Service Bulletin No. 389

MODEL D / E / J Series Coaches	TYPE Field Change Program	SECTION/GROUP 7 – Electrical	DATE Oct. 12, 2012
SUBJECT RETENTION NUT ON LEECE NEVILLE ALTERNATOR			
CONDITIONS

Figure 6. Reference photo.

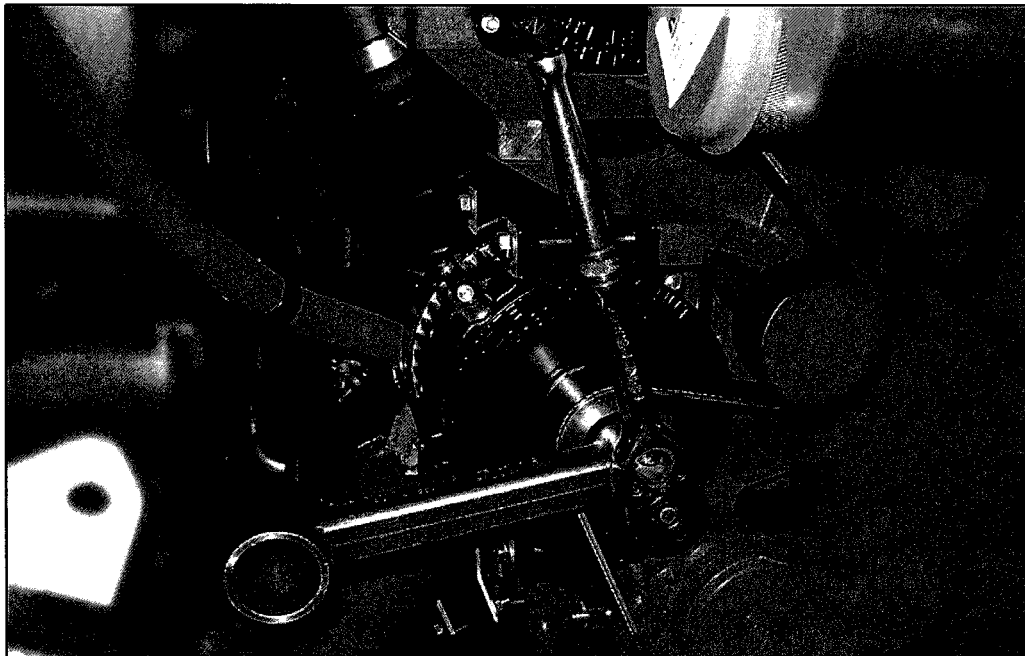
9. Using the two (2) reference tools shown in Figures 5 and 6 simultaneously, remove and discard the existing pulley nut from the alternator.

10. Install and tighten the new nut, p/n 07-03-1285, on the alternator. Torque nut to 70– 80 ft.-lbs.
11. Repeat Steps 9. and 10. to the second alternator.
